AMENDMENT – II

NIT, No. : PNMM/PC-183/E-4011/NCB Dated 20.05.2022

Sub.: COOLING TOWER PACKAGE INCLUDING COOLING WATER TREATMENT SYSTEM ON
PACKAGE BASIS AT TALCHER FERTILIZERS LIMITED, TALCHER, ODISHA

CLIENT : M/s. TALCHER FERTILIZER LIMITED
 LOCATION : TALCHER, ANGUL DISTRICT, ODISHA(INDIA)
 TITLE : PLOT PLAN OF PROPOSED INTEGRATED COAL BASED FERTILIZER AND CHEMICALS COMPLEX
 SCALE :- 1 : 2200
 DRG. No. :- PC183-0000-0001
 FILE :- PC183-0000-0001_Rev 1

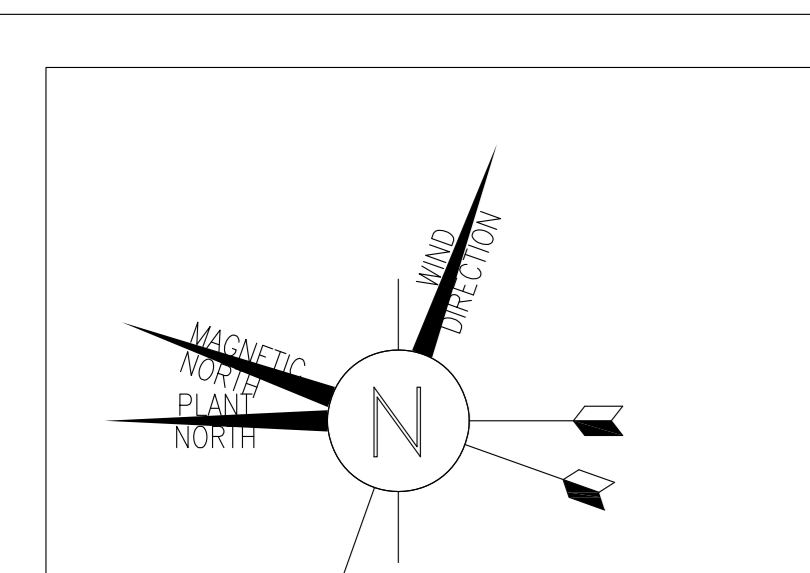
2.	Part VI	356 of 1506		Plot Plan	Drg.no.PC813-0000-0001 Rev.0	M	Drg.no.PC813-0000-0001 Rev.01_OP
3.	Part VI	575 of 1506	3.12	EOT Crane	3.12. EOT cranes LSTK / PACKAGE Contractor to provide EOT Cranes of adequate capacity in various Pump Houses, Compressor & turbine House and other location wherever required for ease in operation and maintenance activities . Cranes to be provided in nearest multiple of 5 Metric Tonnes considering maximum weight to be lifted. Relevant Indian/ ISO Standards to be applicable for EOT Crane. All statutory guidelines to be complied by the contractor/ sub-contractor.	D	Deleted.
